Agenda Bill 2023-07-10-08

Subject: Appeal of the Planning Commission Denial of VAR-23-01

To hold a public hearing and consider an appeal ([AP-23-03](#)) by Tracey & Derek Peterson of [VAR-23-01](#), a Class II Variance at 2622 Marylhurst Drive and 18600, 18680, and 18690 Midhill Circle.

REQUEST: Appeal of the Planning Commission’s denial of VAR-23-01, a Class II variance to allow more than 4 lots (six total) to be served from a private driveway on Marylhurst Drive, approximately midblock between Upper and Lower Midhill Circle.

P:\01-Portland\TPH (Tracy Peterson)\TPH02 (Marylhurst)\TPH02-DWG\GISheets\C3.0 - PLAN AND PROFILE.dwg

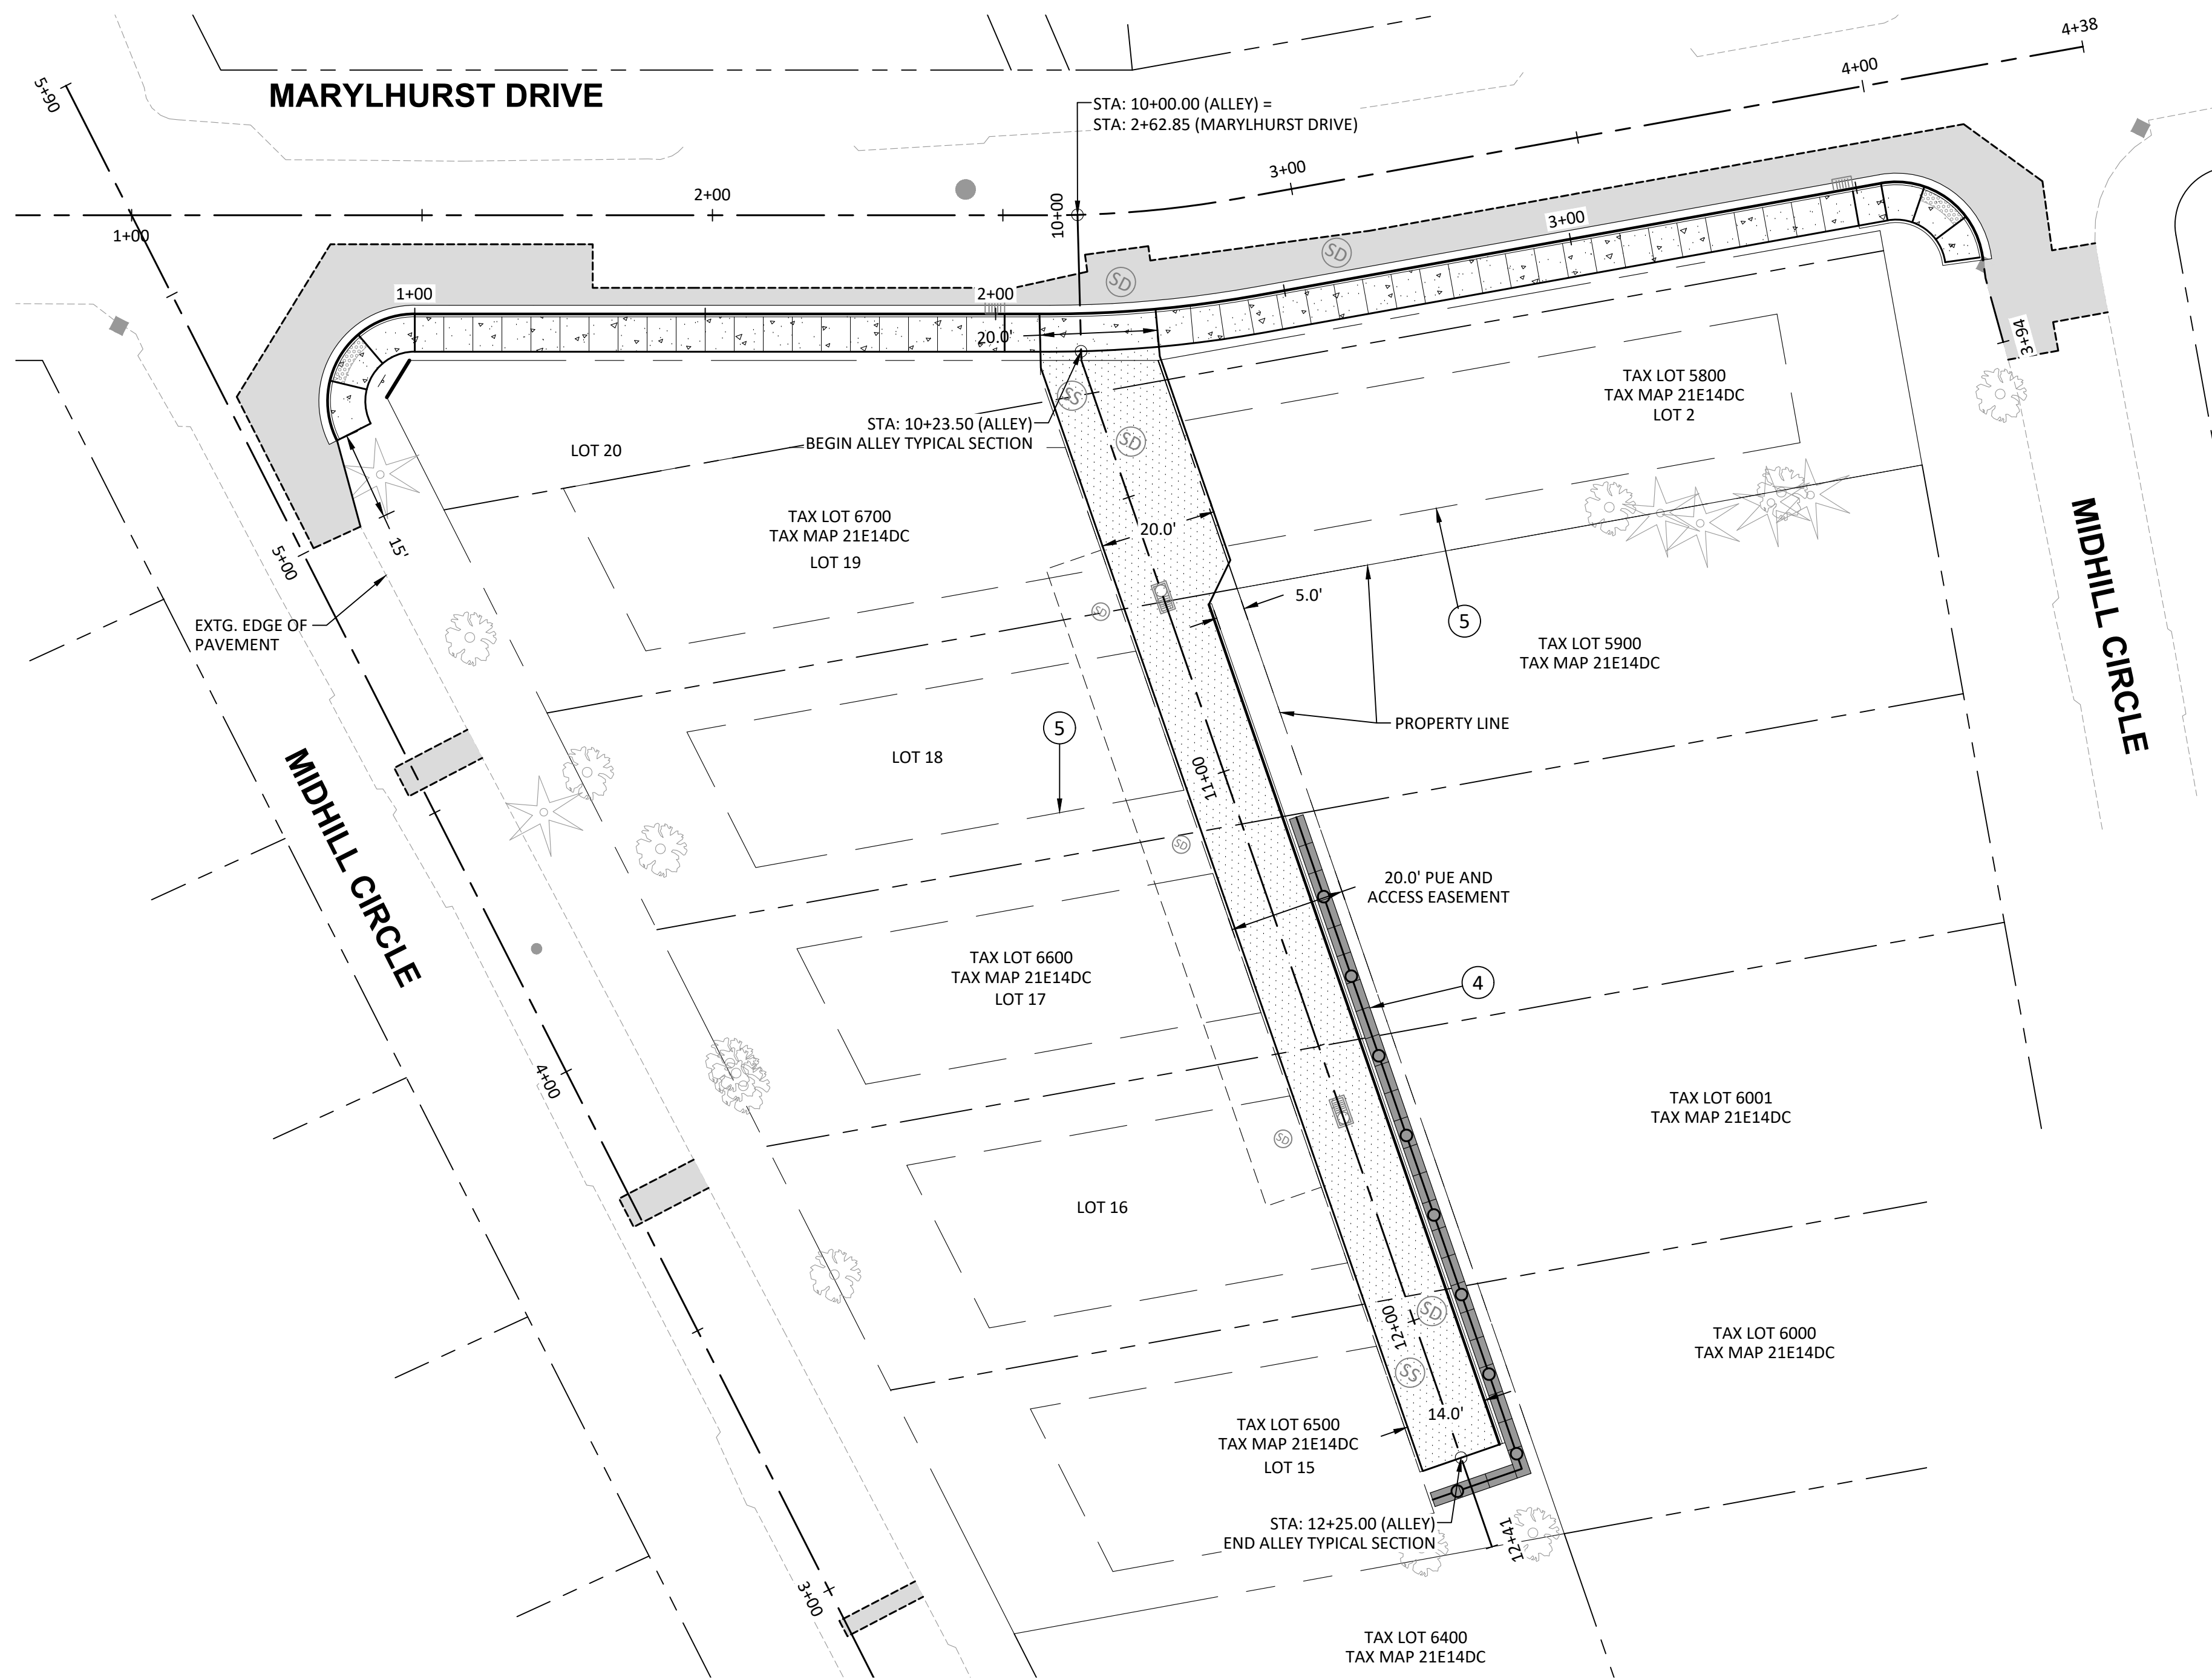
“The Commission finds the applicant did not meet its burden of proof to show all six lots required shared access from one driveway. The applicant did not provide evidence that either the four lots fronting Midhill Circle could not reasonably take access from that street, which would eliminate the need for a variance, or that the spacing standards along Marylhurst Drive could not be met if multiple access points were utilized.”

Response: The applicant is requesting a variance to allow for the consolidation of driveways and allow for all six properties to take access from a single point off Marylhurst Drive. In addition, the applicant will provide frontage improvements along Marylhurst Drive, including a six foot wide sidewalk and new street paving. Please see the attached site plan, Sheet C3.0, for details on the proposed improvements.

Response: The proposed driveway off Marylhurst Drive has a curb cut of 20 feet, complying with the minimum and maximum curb cut width allowed above. Please see the attached site plan, Sheet C3.0, for details.

Response: In the City of West Linn’s Transportation Systems Plan (Figure 17), Marylhurst Drive is classified as a Collector Street and Midhill Circle is classified as a Local Street. Therefore, no curb cut is allowed any closer than 35 feet of these intersecting. The proposed curb cut is well over 100 feet from both intersections, complying with the above standard. Please see the attached site plan, Sheet C3.0, for details.

SHEET NO.
C3.2
 JOB NO.
 TPH-02

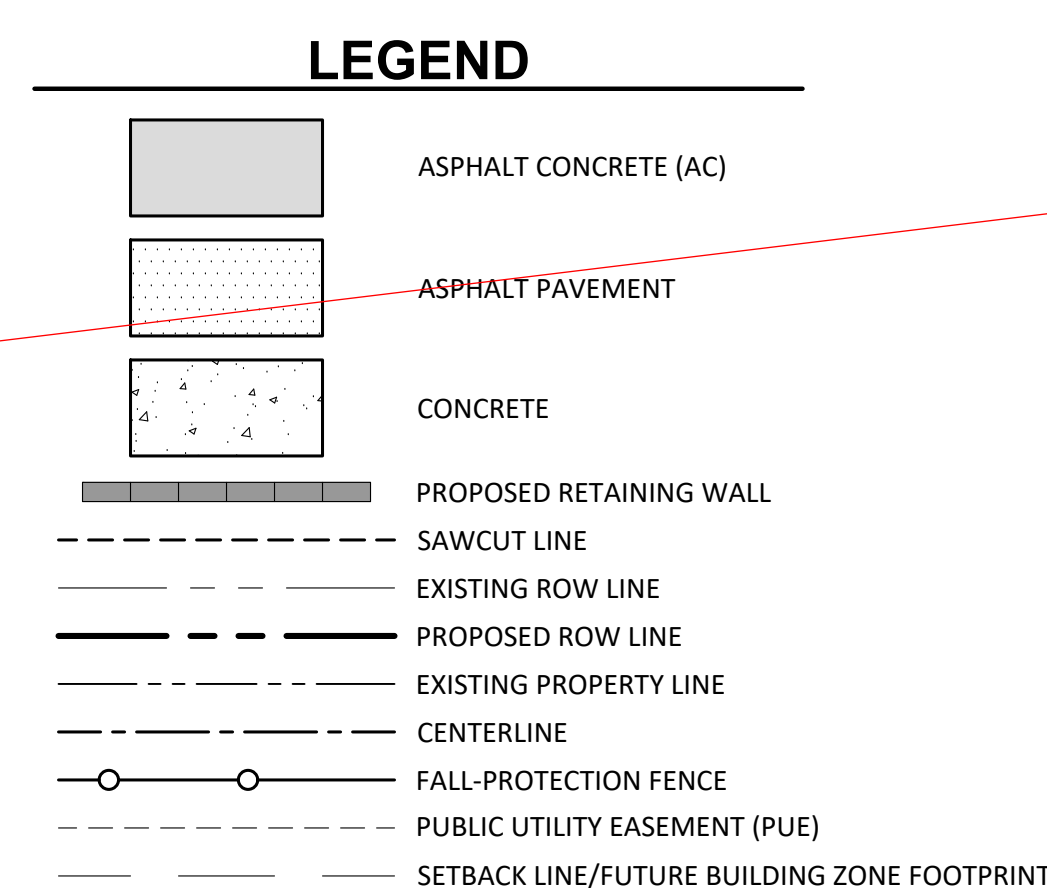
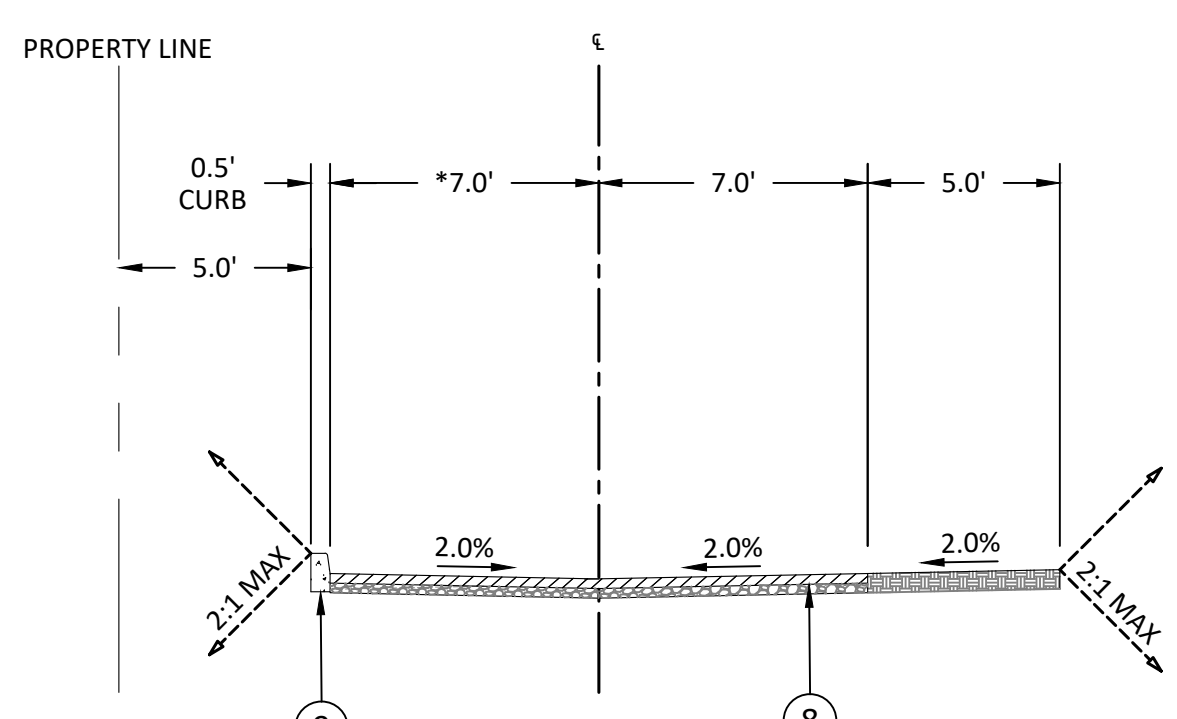
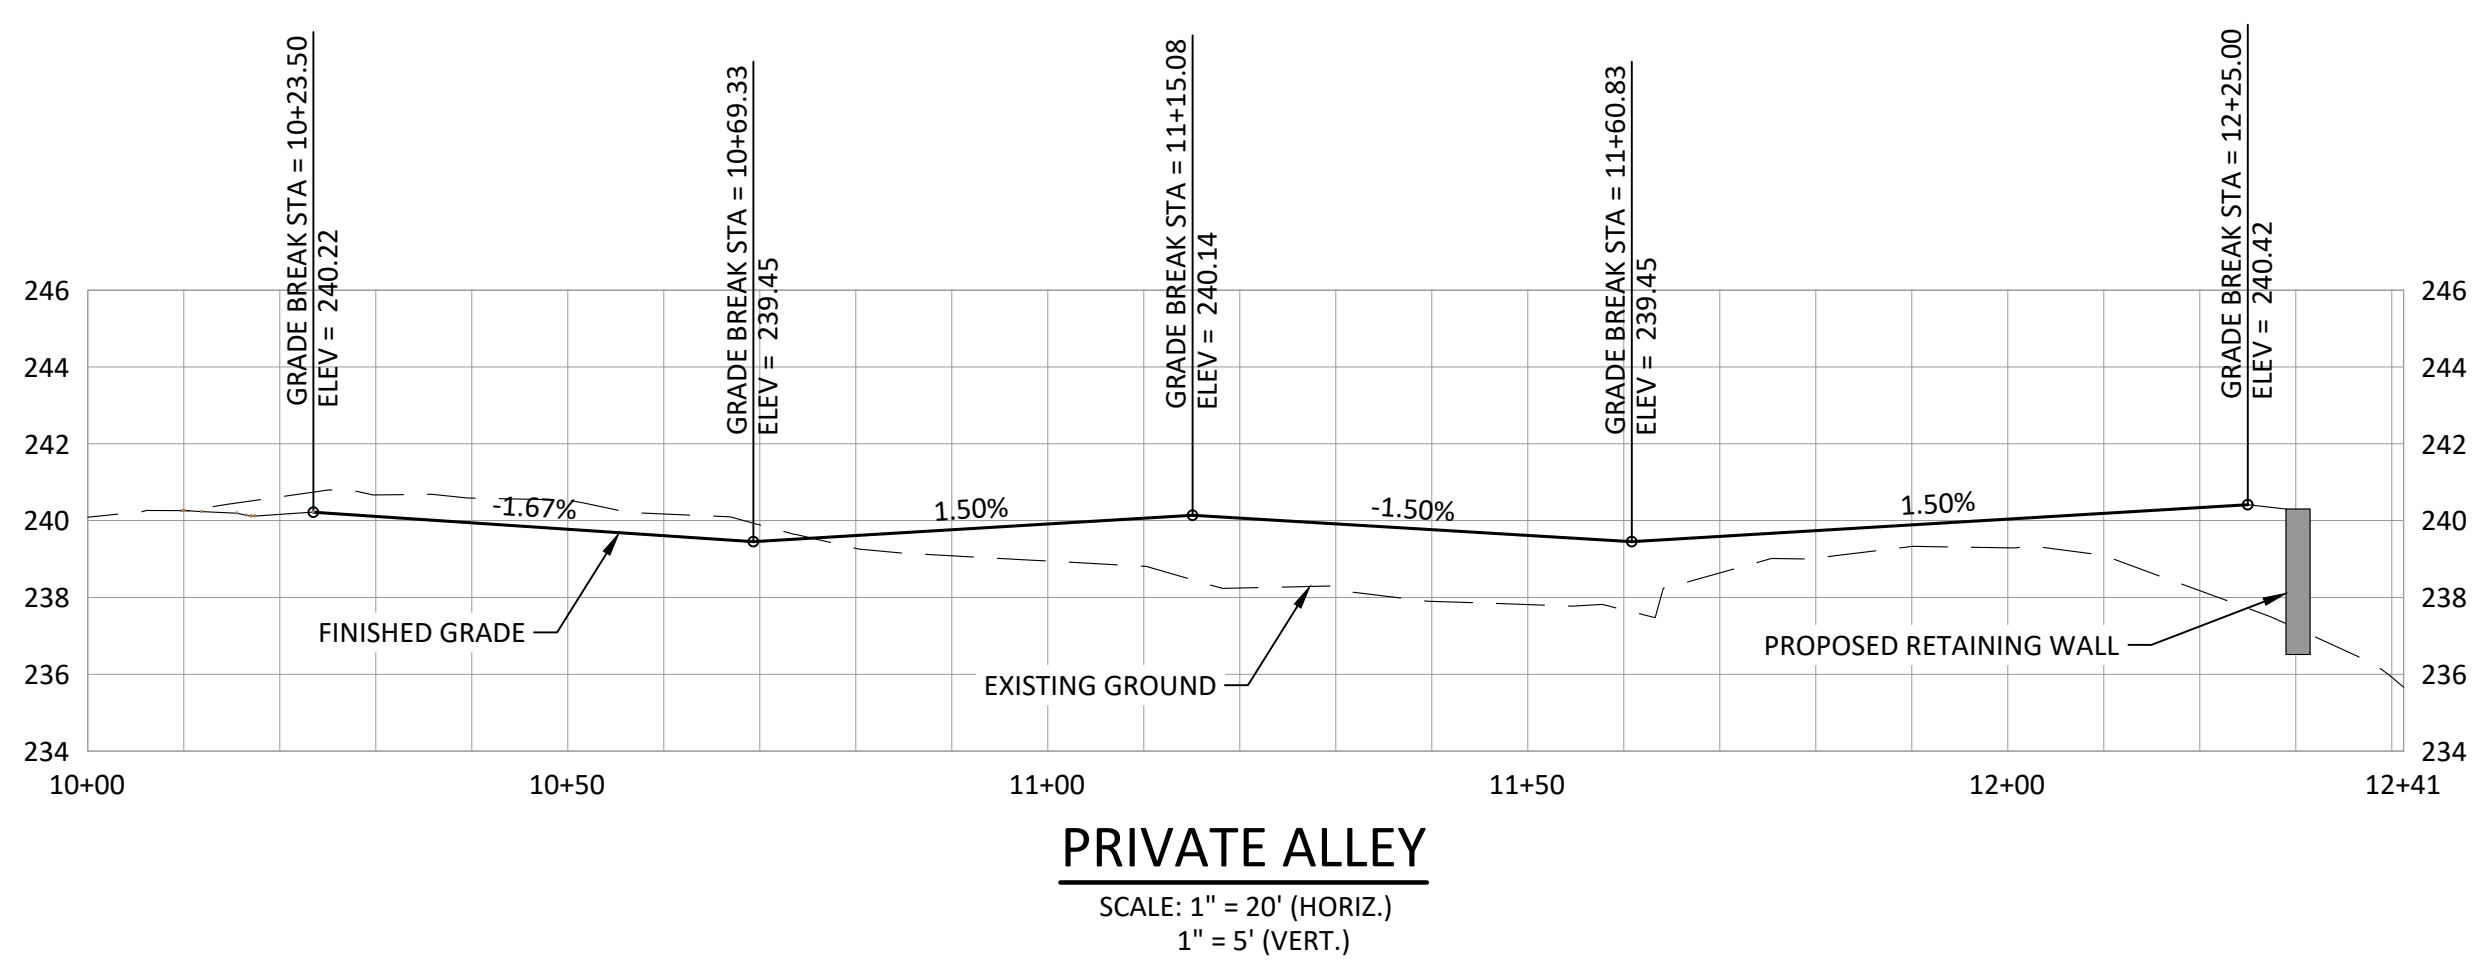
"The Commission finds the applicant did not meet its burden of proof to show compliance with minimum driveway width requirements of 48.030.B(2). The code requires a 14- to 20-foot-wide driveway when servicing two to four single-family lots. The applicant submittal shows the driveway varying from 20 to 14-feet and the Commission interprets the code to require the full 20-foot width for the length as it serves four lots."

As noted above in the procedural history, questions were raised regarding the approval stamps on the TVF&R Service Provider Permit, including a condition requiring the applicant/appellant to construct the roadway to 20 feet in width for the entire length. Planning Staff contacted TVF&R and requested clarification of the Service Provider Permit (SPP), including whether the approval stamps on the site plan required the final design to demonstrate a 20-foot-wide access road along the entire length. In discussing the application, Deputy Fire Marshall Jason Arn confirmed the following:

NO PARKING fire lane signs required along private road. 20' minimum road width OFC D103.6.1-2.

- The notation on SPP-2023-0034 requires the posting of “No Parking” signs, and does not require the applicant to widen the proposed design. The reference to a 20’ minimum road width is a result of you not being allowed to modify fire code language when stamping plan sheets.

Response: Standard 48.030(B)(2), referenced by Planning Commission, requires a driveway to be between 14 and 20 feet wide when serving two to four single family homes. The requested variance by the property owner would allow the driveway to serve six single-family lots (there are no existing or proposed homes with this application) and consolidate six potential single driveways into one to eliminate the need for significant grading. The driveway has been designed to be 20 feet wide where the driveway meets Marylhurst Drive and then is reduced down to 14 feet wide for the remainder of the driveway. The reduced driveway width would serve four of the six lots and would be approximately 150 feet in length. This design, which is supported by both Tualatin Valley Fire and Rescue and the City's Engineering Division, allows for emergency vehicles to fully pull into the private driveway without blocking any of the street on Marylhurst Drive while also providing a buffer between the project site and the existing home to the east off Midhill Circle that is not part of the project site.
